HISTORIC AND DESIGN REVIEW COMMISSION

November 06, 2019

HDRC CASE NO: 2019-616
ADDRESS: 1910 E HOUSTON ST
LEGAL DESCRIPTION: NCB 1372 BLK 40 LOT 40 (HOUSTON STREET DEVELOPMENT)
ZONING: IDZ, H
CITY COUNCIL DIST.: 2
DISTRICT: Dignowity Hill Historic District
APPLICANT: SA HOUSTON STREET DEVELOPMENT PARTNERS LLC
OWNER: SA HOUSTON STREET DEVELOPMENT PARTNERS LLC
TYPE OF WORK: Front and rear yard fence
APPLICATION RECEIVED: October 15, 2019
60-DAY REVIEW: December 14, 2019
CASE MANAGER: Huy Pham
REQUEST:

The applicant is requesting a Certificate of Appropriateness for approval to construct a 4 foot tall cattle panel fence around the property, excluding the driveway.

SITE PLAN

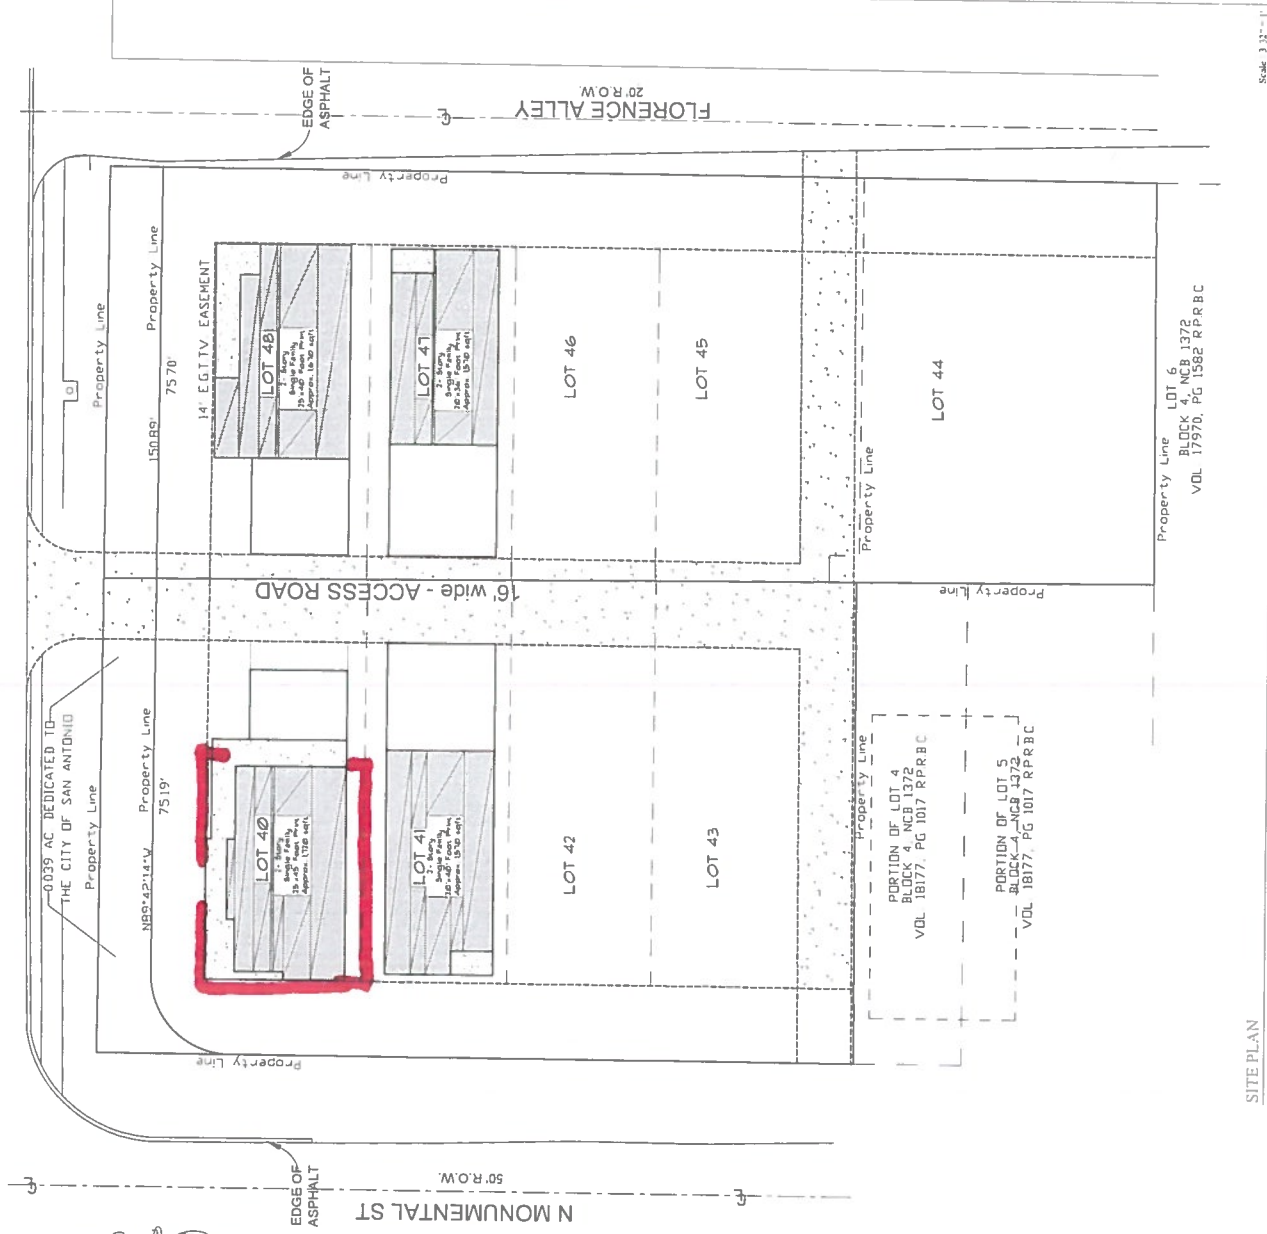
- i. That the applicant ensure that foundation heights are consistent with the Guidelines and within one foot of those found historically in the vicinity of the proposed new construction as noted in finding g.

RESPONSE:
 Elevation have been revised to reflect the sashes in all windows and added more elements at voided fenestration
- ii. That all composite siding feature an exposure of four inches and a smooth finish.

RESPONSE:
 All horizontal siding will be James Hardie, 25" lap siding which gives a finished exposed 6" reveal
- iii. Standing seam metal roofs should feature panels that are 18 to 21 inches wide, seams that are 1 to 2 inches tall, a crimped ridge seam and a standard galvalume finish. If a ridge cap is to be used, it shall be presented to staff at the time of final approval and should be minimal in profile with a height of less than two inches.

RESPONSE:
 All metal roofs illustrated are to be 21" Galvalume panels with a max of 2" tall seams
- iv. That wood or aluminum clad wood windows be installed has not noted window materials. Staff recommends the installation of wood or aluminum clad wood windows. While manufacturer's color is not allowed, and color selection must be presented to staff. There should be a minimum of two inches in depth between the front face of the window trim and the front face of the top window sash. This must be accomplished by recessing the window sufficiently within the opening or with the installation of additional window trim to add thickness. Window trim must feature traditional dimensions and an architecturally appropriate sill detail. Window track components must be painted to match the window trim or concealed by a wood window screen set within the opening.

- v. That column details be submitted to staff when returning for final approval as noted in finding m.
RESPONSE:
 Please detail on elevation sheets
- vi. That gable returns/soffit boxes be eliminated as noted in finding n.

RESPONSE:
 Complete and illustrated on each sheet
- vii. That the proposed new construction on lot 48 feature a transom window above the proposed front door and a window or door on both levels one and two where the wraparound porch terminates.

RESPONSE:
 Request has been drawn in on Lot 48 front elevation. Second level only has access to patio on West elevation
- viii. The proposed new construction on lot 47 should feature a smaller window adjacent to the front door, or a centered door with side lites and a transom window. All transom windows should feature divided lites.

RESPONSE:
 All finish floor heights will be a minimum 12" above grade
 That proposed fixed windows feature sashes and that additional fenestration be added to facades that are currently void of fenestration.

RESPONSE:
 All windows are to be aluminum clad with dark brown finish color. Installation of all windows will be recessed as required by HDRC design criteria with window trim material surround to provide additional depth to the window profile

RESPONSE:
 Request has been drawn in for elevation at Lot 47
